APPLICATION NO.	FILING DATE	FIRST NAMED INVENTOR	ATTORNEY DOCKET NO.	CONFIRMATION NO.
09/678,414	10/02/2000	David W. Carlson	NSC1-H1700 [P04797]	4381
33402	7590	11/08/2006	EXAMINER	
LAW OFFICES OF MARK C. PICKERING			KEBEDE, BROOK	
P.O. BOX 300			ART UNIT	
PETALUMA, CA 94953			PAPER NUMBER

Office Action Summary

09/678,414

**FIG. 2D**

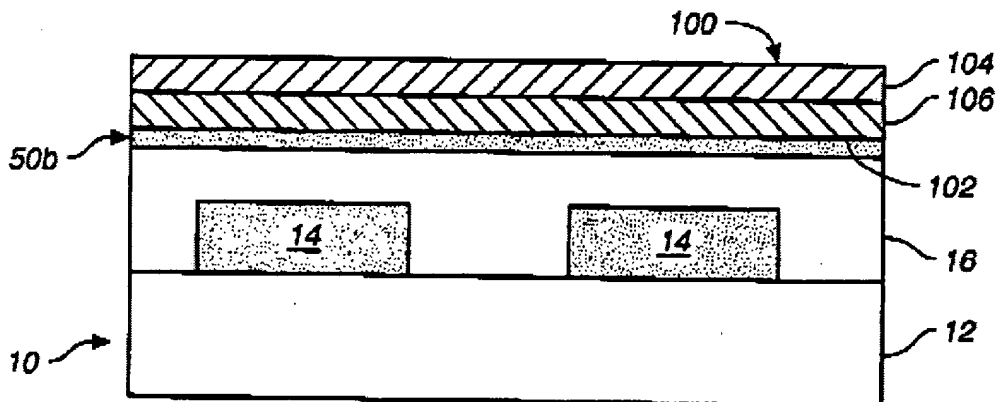
Applicant further argued that “As shown Fig. 2C, Li teaches the native oxide layer 18, *the second material*, has been removed, from polysilicon 16, the first material, but Li totally fail to teach or suggest that the polishing continues until substantially all the native oxide layer 18 has been removed at which time polysilicon layer 16 has a substantial planar top surface as required by claims...”

In response to the applicant's argument, it is respectfully submitted that Li et al. '368 disclose all the claimed limitations the instant application as claimed in claims 31-36, 38-46 and 49-52 as applied above. For example, as shown in Fig. 2D and presented herein below, the first material layer 16 does actually polished to have planar surface prior layer 50b , 106 and 104 are deposited. The removal of the second material layer 18 and planarizing of the second material

16 is happened concurrently within short period of time by CMP process (see also Col. 6, lines 1-5). In addition, with respect to applicant's argument, it is not clear how could be possible that polishing of layer 16 with out removing of layer 18.

**FIG. 2G**

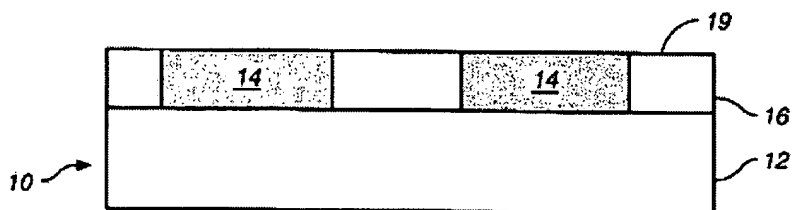
After the CMP process and removal of the material layer 18, the first material layer 16 having a substantially planar surface 19 as shown in Fig. 2G herein below.

Further in response to applicant's contention, it is respectfully submitted the instant application claimed invention does not specifically disclose to the degree of certainty that instant application CMP process will result a perfect planar surface that cannot be achieved by the CMP

process of Li et al. '368. There is no evidence can be found in the instant application to the contrary of Li et al. '368 disclosure.

FIG. 2I

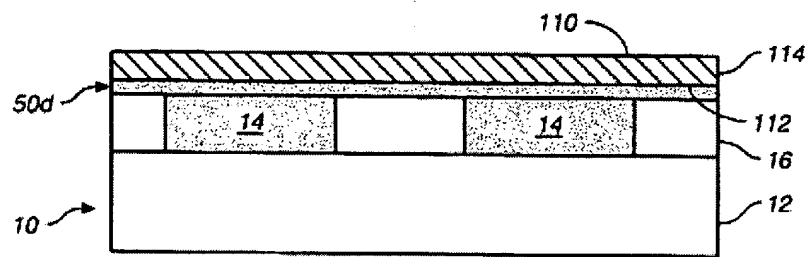
Applicant further argues that "Li fails to teach or suggest formation of third material as claimed ..."

In repose to applicant's argument, it is respectfully submitted that Li et al. '368 disclose all the claimed limitations of the instant application as claimed including forming of third material over the planarized second material 16. For example, Fig. 2I as shown below material layer 114 is meets the claim language third material layer as applied in the rejected claims in Paragraph 4 above.

Further in response to applicants contention that "*Li does not teach or suggest wherein the third layer is a mask layer ...*," it is respectfully submitted that "mask" layer does not have any special meaning as claimed in claims 39 and 50 because applicant does not define what the mask layer entails or represent in terms of it function and usage. Since "mask" has a very broad interpretation and function in the semiconductor industry, the "pad" layer is analogous to "mask" for CMP process. In addition based on the plane interpretation of the "mask" and examining of applicants evidence in Appendix "C", it is respectfully submitted examiner's interperation is
